1CAN040302

April 2, 2003

SUBJECT: Arkansas Nuclear One, Unit 1 (ANO-1)
Docket No. 50-313
License Amendment Request to Modify the Fuel Assembly
Enrichment, the Spent Fuel Pool (SFP) Boron Concentration Technical
Specification (TS) 3.7.14, the Loading Restrictions in the SFP in TS
3.7.15, and to Modify the Fuel Storage Design Features in TS 4.3

Analysis of Proposed Technical Specification Change

Figure 3.7.15-1
Burnup versus Enrichment Curve for
SFP Storage Racks Region 1

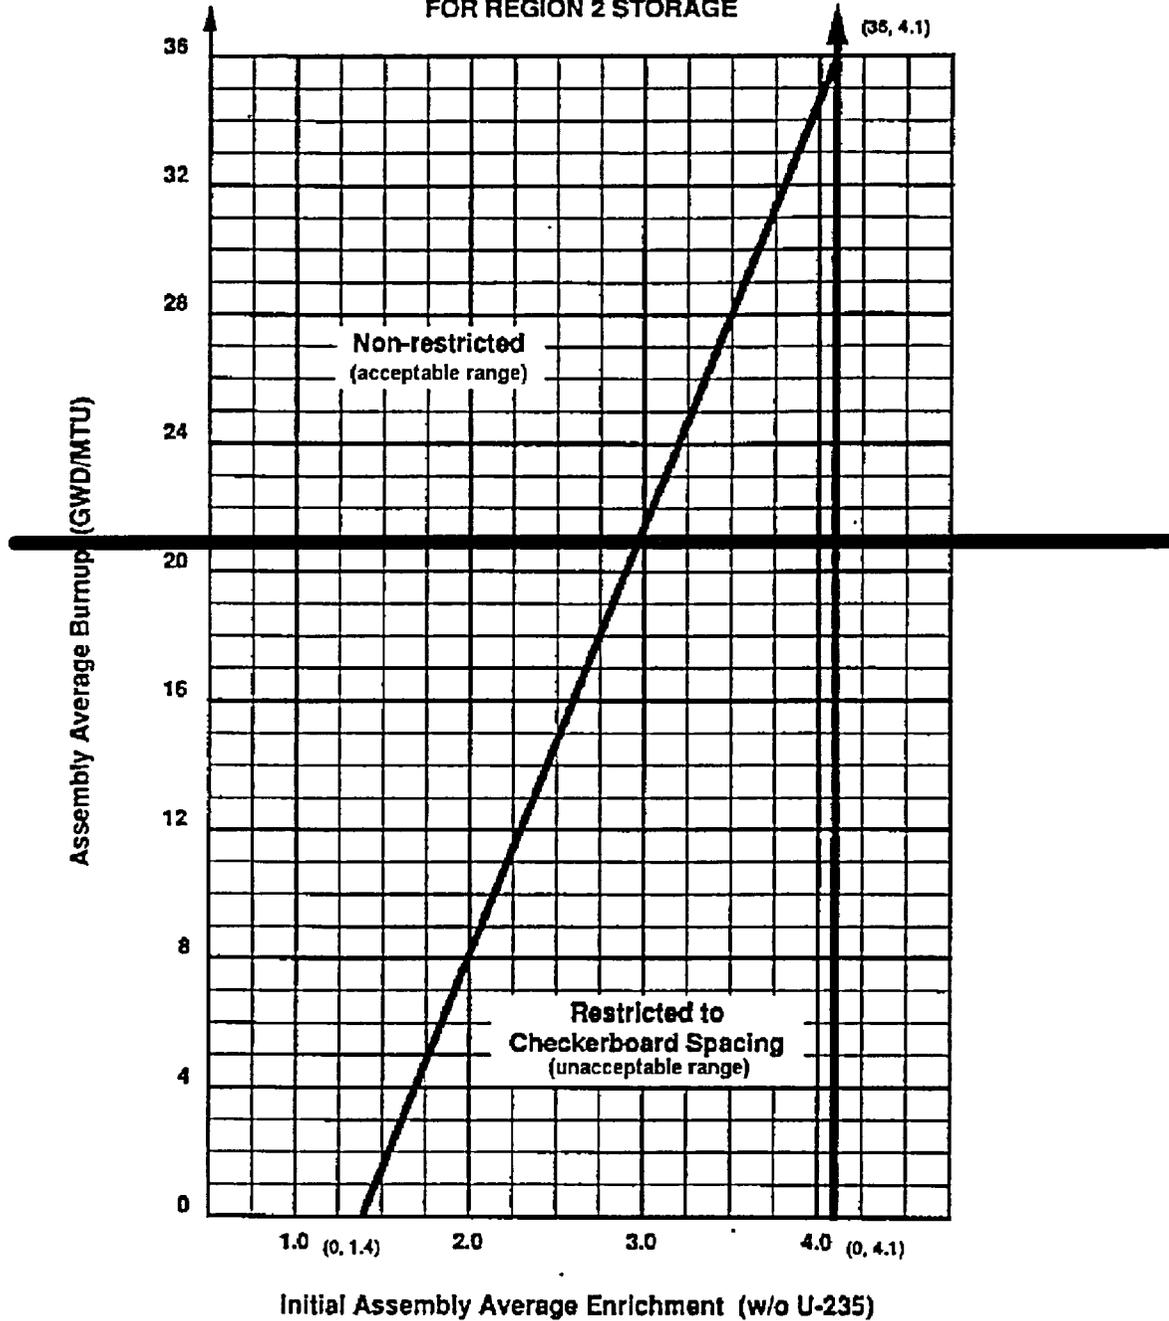
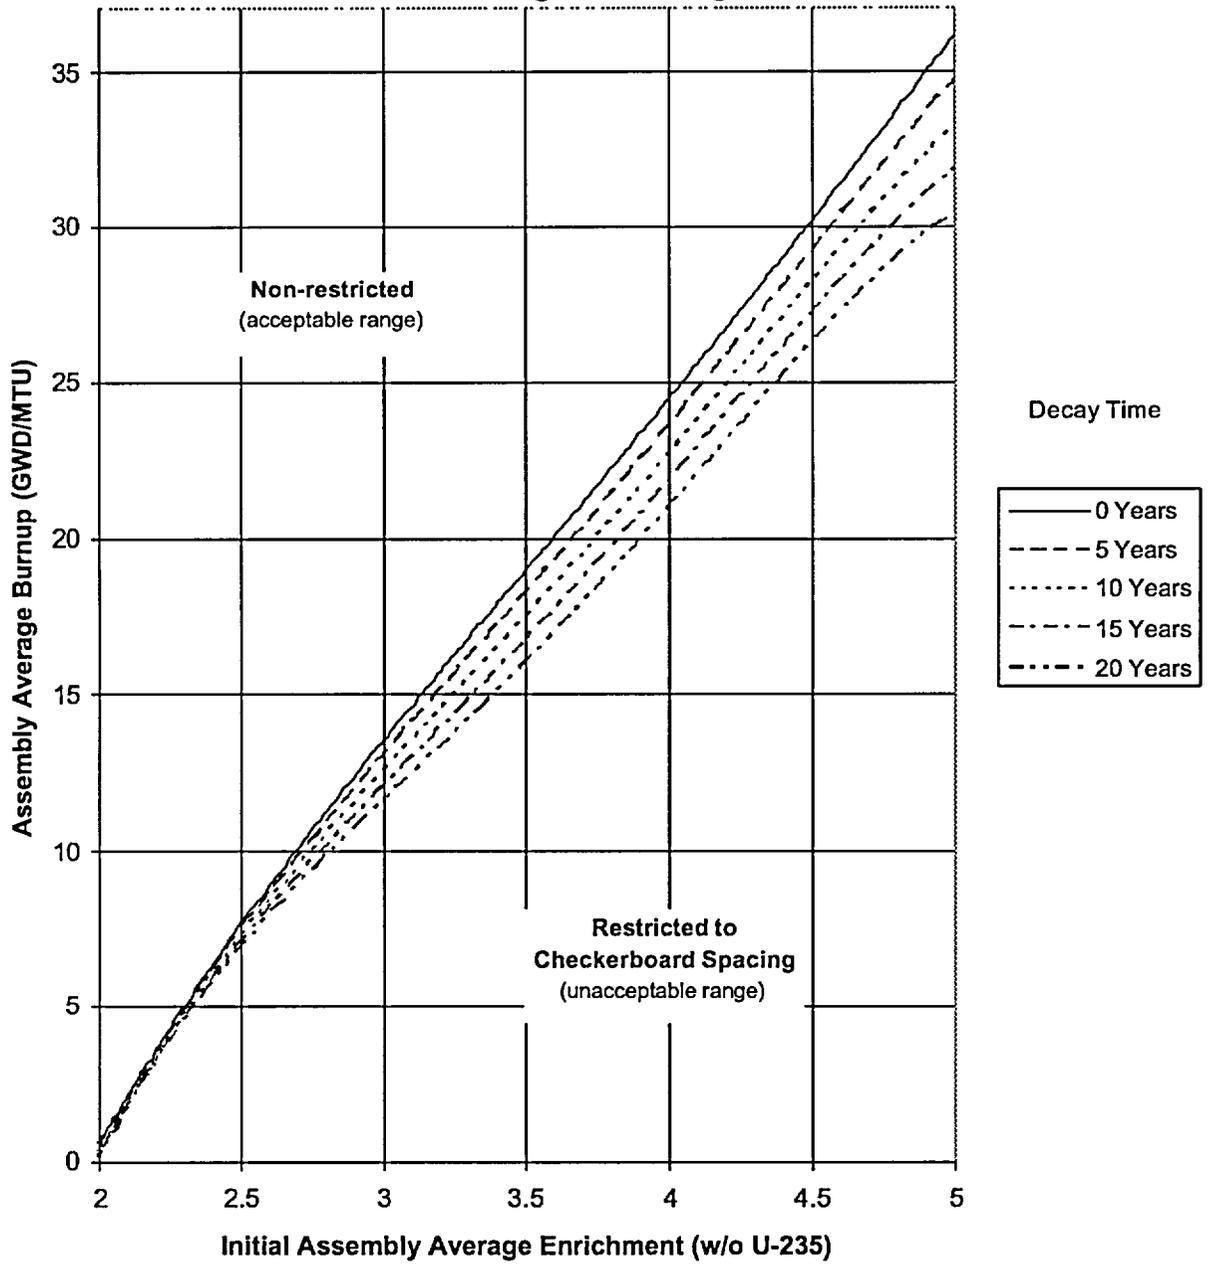
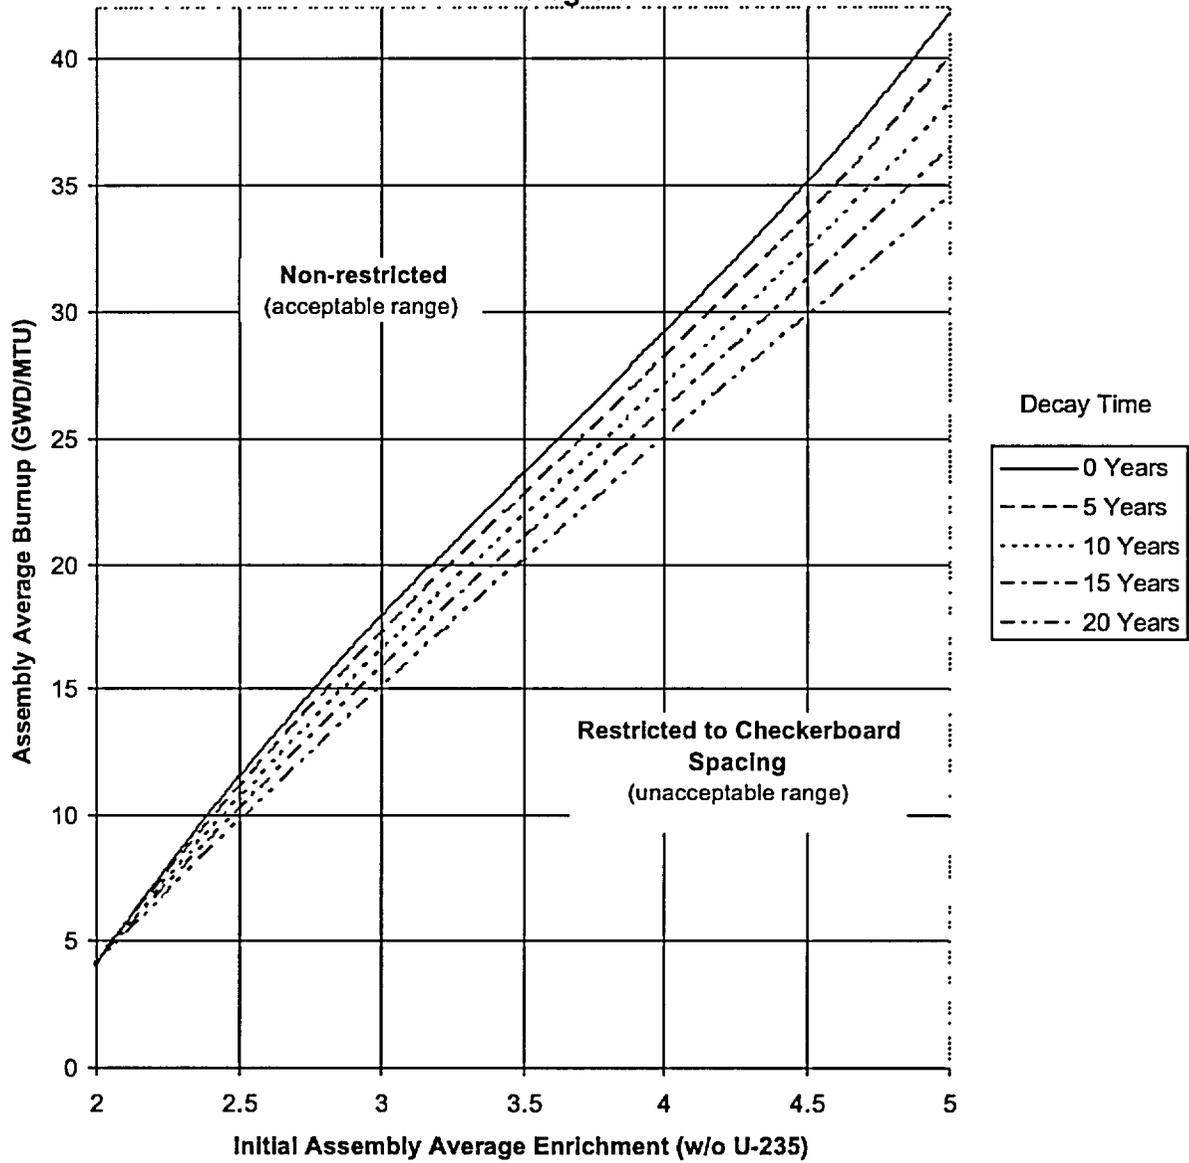
ANO-1 TS 3.7.15 and Figure 3.7.15-1 define loading restrictions for any fuel assembly that is stored in Region 2 of the ANO-1 SFP. Currently, no loading restrictions are required by TS in SFP Region 1, which allows storage of new and spent fuel. Region 1 contains Boraflex® poison panels. Calculations indicate that the Boraflex® content in Region 1 will degrade below the original Boraflex® content assumed in the criticality analysis (Reference 2). Based on continued projected degradation of Boraflex®, the proposed change will take no credit for Boraflex® in Region 1 and will include loading restrictions for Region 1. This will result in changes to TS 3.7.15 and Figure 3.7.15-1, and the creation of a new Figure 3.7.15-2 based on new criticality analysis for Regions 1 and 2. In addition, a portion of the SFP racks in Region 2 will be modified by the installation of Metamic® poison panel inserts. This will result in the creation of a new Region 3 that will allow unrestricted storage of new and spent fuel. Entergy has submitted a topical report (Reference 1) that describes the physical and chemical properties of Metamic®. Approval of the topical report is required to allow the use of Metamic® in SFP applications.

TS 3.7.15, Figure 3.7.15-1, TS 4.3.1.1.d, and TS 4.3.1.1.e currently define loading restrictions for Region 2 based on the combination of initial enrichment and burnup of each spent fuel assembly. The loading restrictions were defined by the approval of TS Amendment 76 (NRC Safety Evaluation Report (SER) dated April 15, 1983) which allowed modification of the ANO-1 SFP storage capabilities from 589 spaces to 968 spaces. The expansion was accomplished by

- ed. A nominal 10.65 inch center to center distance between fuel assemblies placed in the storage racks;
 - de. New or partially spent fuel assemblies with cooling times and a discharge burnup in the "acceptable range" of Figure 3.7.15-1 or Figure 3.7.15-2 allowed unrestricted storage in either fuel storage rack Region 1, or Region 2; or Region 3, and

- ef. New or partially spent fuel assemblies with cooling times and a discharge burnup in the "unacceptable range" of Figure 3.7.15-1 or Figure 3.7.15-2 stored in Region 13, or in checkerboard configuration in either Region 1 or Region 2.

Fresh or spent fuel with enrichments up to 5.0 wt% U-235 may be stored in Region 1 and/or Region 2 per TS 3.7.15 Figures 3.7.15-1 (Region 1) and 3.7.15-2 (Region 2). The figures use initial U-235 enrichment and burnup to determine loading restrictions. The five curves on each figure represent decay time in years. Decay time is based on the time at which an assembly is permanently placed in the pool (i.e., if an assembly is placed in the pool one cycle and then returned to the core, the initial time in the pool is not included in the decay time once the assembly is permanently removed from the core.) The following equations were used to generate the decay curves and may be used to interpolate fuel placement in restricted or non-restricted regions:

Figure 4.10.2: Acceptable New Fuel Storage Vault Configuration for up to 4.95 wt% Enrichment Fresh Fuel

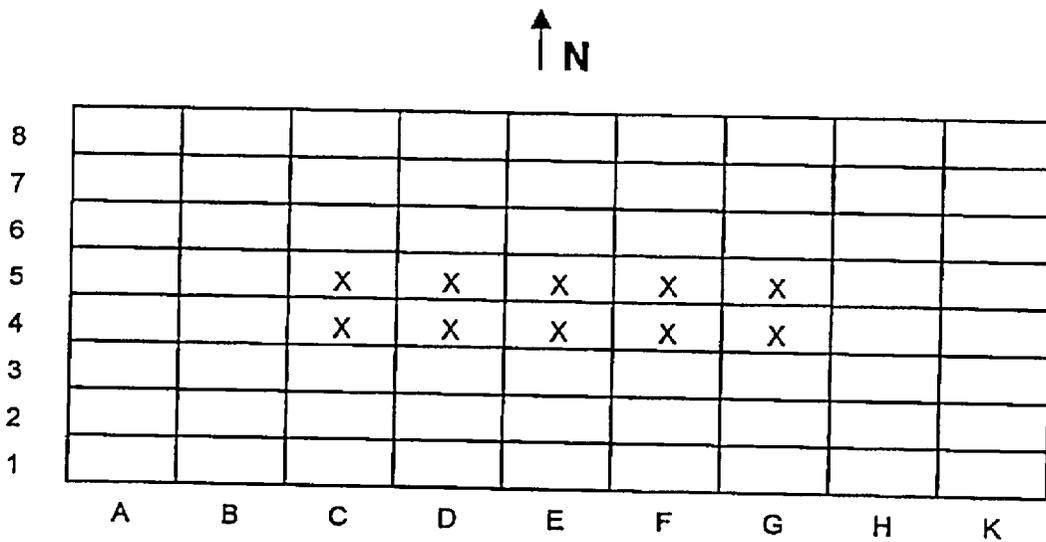
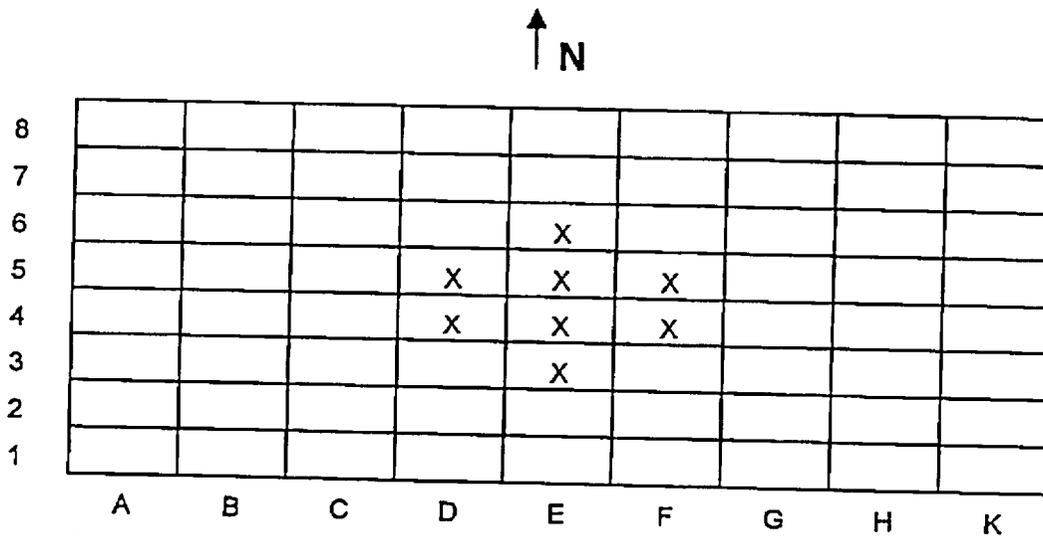
ANO-1 Figure 4.3.1.2-1 depicts locations in the fresh fuel storage racks in which fuel loading is prohibited. Based on the increase in fuel assembly enrichment from 4.1 w/o to a maximum enrichment of 5.0 w/o, two loading pattern configurations will be proposed, which will result in the addition of a new Figure 4.3.1.2-2. Figure 4.3.1.2-2 will depict the loading pattern associated with fuel assemblies whose enrichment is up to 4.2 w/o and Figure 4.3.1.2-1 will illustrate the loading configuration for fuel assemblies whose enrichment is up to 5.0 w/o. A change is also proposed to TS 4.3.1.2.d and e to state that the fuel storage racks shall be maintained in accordance with the two proposed figures which are based on fuel enrichment.

The criticality analyses also include consideration for storage of fuel assemblies with a maximum U-235 enrichment of 5.0 w/o. Analyses were performed for the new fuel storage racks and the SFP racks considering storage of the higher enrichment. A new storage configuration is included in the proposed change for the new fuel storage racks.

Additional calculations at 9% moderator density, performed for the storage pattern depicted in Figure 4.10.3, show that this storage configuration is acceptable for storage of fresh fuel assemblies of up to 4.20 wt% enrichment with four locations in each rack array required to remain empty.
